TRANS/WP.29/GRSP/2003/3
21 March 2003

Working Party on Passive Safety (GRSP)

PROPOSAL FOR DRAFT AMENDMENTS TO REGULATION No. 17
(Strength of seats)

Annex 5, the figure, amend to read:

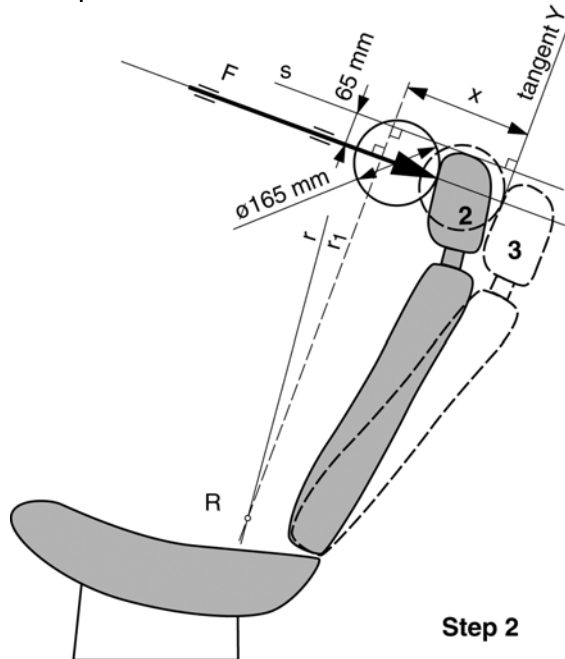
Note: The text reproduced below was prepared by the expert from the Czech Republic in order to better define the figure of annex 5 to the Regulation. It is based on a document distributed without a symbol (informal document No. 17) during the thirty-second session (TRANS/WP.29/GRSP/32, para. 17).

1. Original unloaded position
2. Displaced position by a moment of 37.3 daNm of manikin's back in relation to R point
3. Position after displacement by an initial force F producing a moment of 37.3 daNm about R point

VERSION B: x compatible with paragraph 6.4.3.5.
